Agenda Item # 15
BOA-003635-2026

Location:
720 Museum Drive

- Large Building Footprint, Reduced Landscape Area, Increased Parking, Reduced Street Trees, and Public Access Variances to allow a structure larger than 20,000 square feet, reduced front landscaped area, provision of more parking spaces than allowed, a reduced number of street tree plantings, and reduced public access doors on a site currently zoned B-2, Neighborhood Business Suburban District, within the Neighborhood General sub-district of the Spring Hill Overlay.

APPLICATION NUMBER <u> 6741 </u> DATE <u> March 2, 2026 </u>	 NTS
APPLICANT <u> Museum Partners, LLC </u>	
REQUEST <u> Building Footprint, Reduced Landscape Area & Street Trees, Increased Parking & Public Access Variances </u>

SITE PLAN

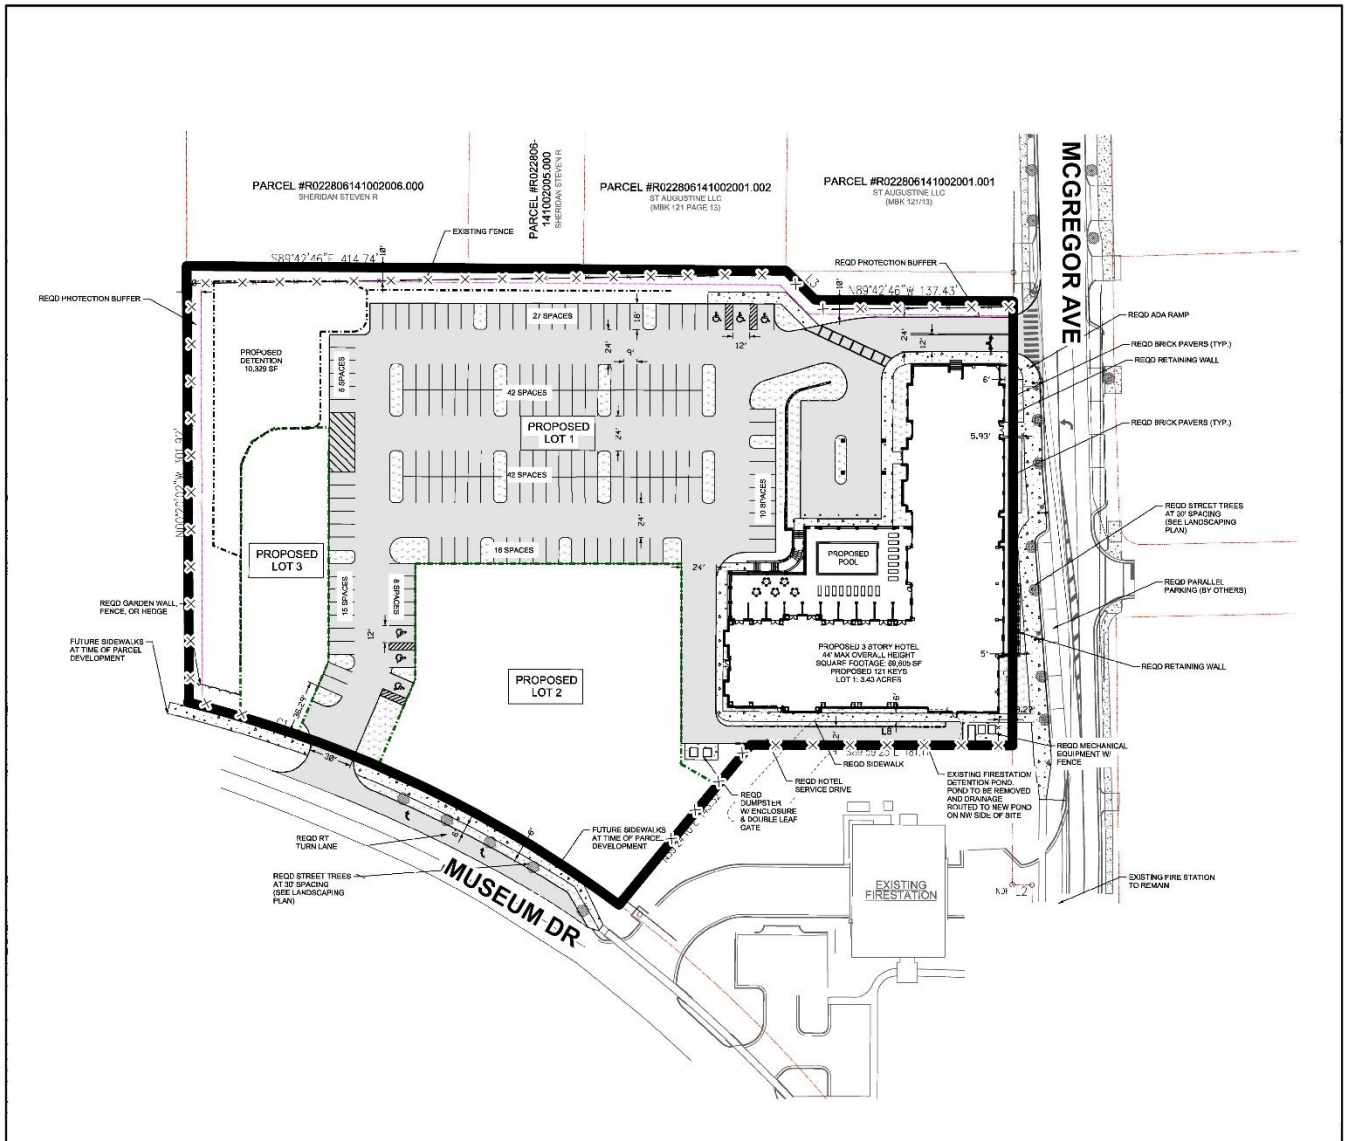
It should be noted that the applicant has submitted a three (3) lot Subdivision application, which is scheduled to be considered by the Planning Commission at its March 19th meeting. As such, the site plan submitted only depicts proposed development on the proposed Lot 1. If approved, a copy of that recorded Subdivision should be submitted to staff prior to the issuance of permits.

The applicant is proposing to construct a new building on the proposed Lot 1, which would house a hotel with 121 rooms. Because the previous Use Variance application stated the development would only have 87 rooms, and the site plan layout has changed significantly, it should be noted that the applicant will need to submit a new Use Variance to amend to previously approved Use Variance prior to the issuance of permits.

Chapter 64, Article 13-5.B.4.(a). of the UDC only allows buildings with footprints exceeding 20,000 square feet in Village Center and Neighborhood Center Sub-Districts of the SHO, and not within the Neighborhood General Sub-District of the SHO. The applicant states the first floor will have a footprint of 22,408 square feet, while the overall hotel will have 69,605 square feet.

Chapter 64, Article 13-6.C. of the UDC states that no more than 20% of the required minimum amount of off-street parking shall be provided. Hotels are required to provide one (1) parking space per two (2) rooms, thus requiring 61 parking spaces for a hotel with 121 rooms. The applicant is proposing to provide parking that will accommodate the other two (2) lots of the Subdivision and depicts a total of 166 parking spaces. It should be noted that no development is depicted on the other lots, but the narrative submitted mentions a possible retail use that would require 19 parking spaces, a coffee shop that would require 5 parking spaces, and an events center which would require 29 parking spaces, for a total of 114 required parking spaces. If the site is developed in a manner similar to that proposed, 166 will still exceed 20% of the total minimum required parking spaces for all lots. The applicant states the need for the additional parking on-site is due to the lack of overflow or other nearby commercial parking lots for use when the hotel is at full capacity, has a full staff, and the other businesses on the site are operational.

Finally, Chapter 64, Article 13-5.B.2.(c)(2) of the UDC requires public access to street be provided no further than 50-feet apart to provide pedestrians frequent opportunities to enter buildings and to minimize any expanses of inactive wall. The applicant requests having a single door for public access from North McGregor Avenue due to the use of the structure as a hotel.

- 1) Submittal of the required copies of the recorded Fort Hardman Subdivision, Resubdivision of Lots 1 & 2 to staff;
- 2) Either submittal of the required copies of the recorded three-lot Subdivision to be considered by the Planning Commission on March 19, 2026 (if approved) or revision of the site plan to depict the entire lot as it exists (if Subdivision is denied);
- 3) Submit a new Use Variance to amend to previously approved Use Variance prior to the issuance of permits; and
- 4) Full compliance with all municipal codes and ordinances.

LANDSCAPE SITE PLAN

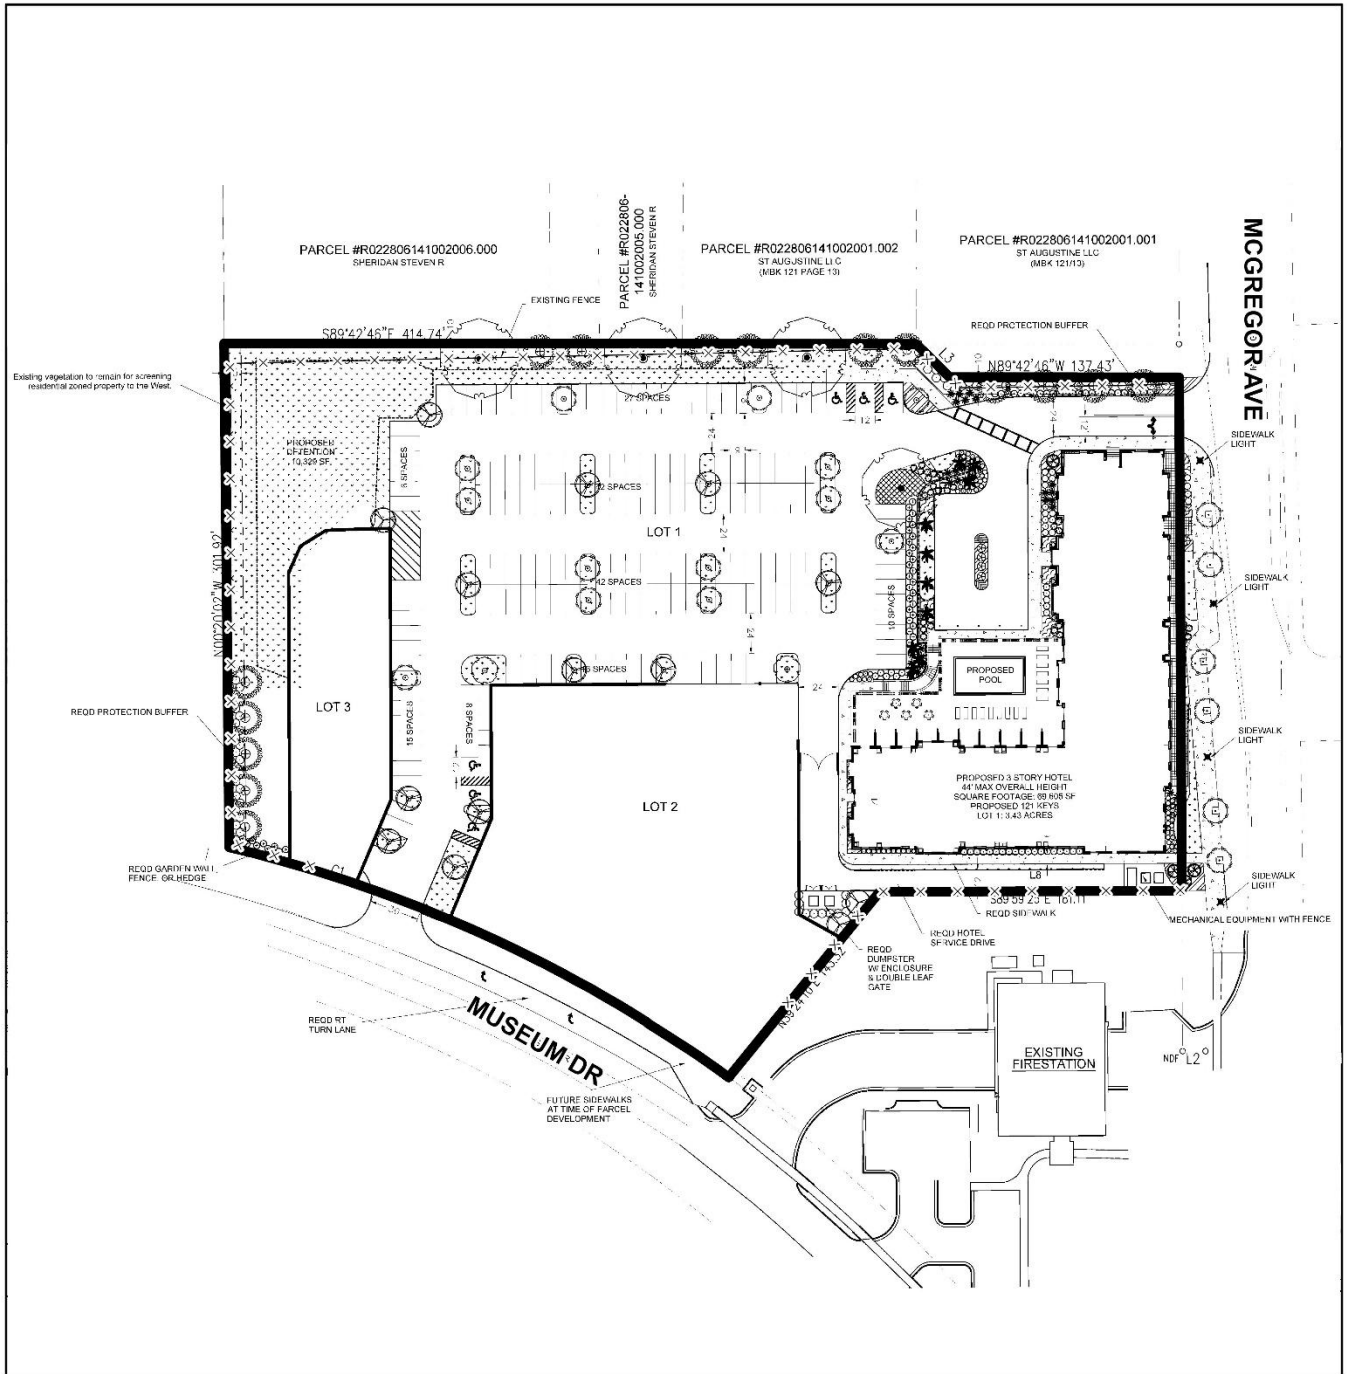
Chapter 64, Article 2-13.E.10. of the UDC requires a minimum of 15% of the overall site to landscaped, while Chapter 64, Article 3-7.A.2.(a)(2). of the UDC requires at least 60% of the total amount of landscaped area for a site be located between the proposed building and the street. The applicant states that because buildings within the Neighborhood General Sub-District of the SHO are required to be setback from front property lines between

six-feet (6') and eighteen-feet (18'), there is limited room available for front landscaped areas. The applicant does propose 20.5% of the overall site to be landscaped, exceeding the minimum amount required.

Chapter 64, Article 13-5.D.6. of the UDC requires street trees to be planted approximately 30-feet apart. The applicant states that in coordination with the City of Mobile for planned streetscape improvements, they are requesting that they be allowed to space street trees further apart, resulting in six (6) trees being planted, instead of nine (9) trees.
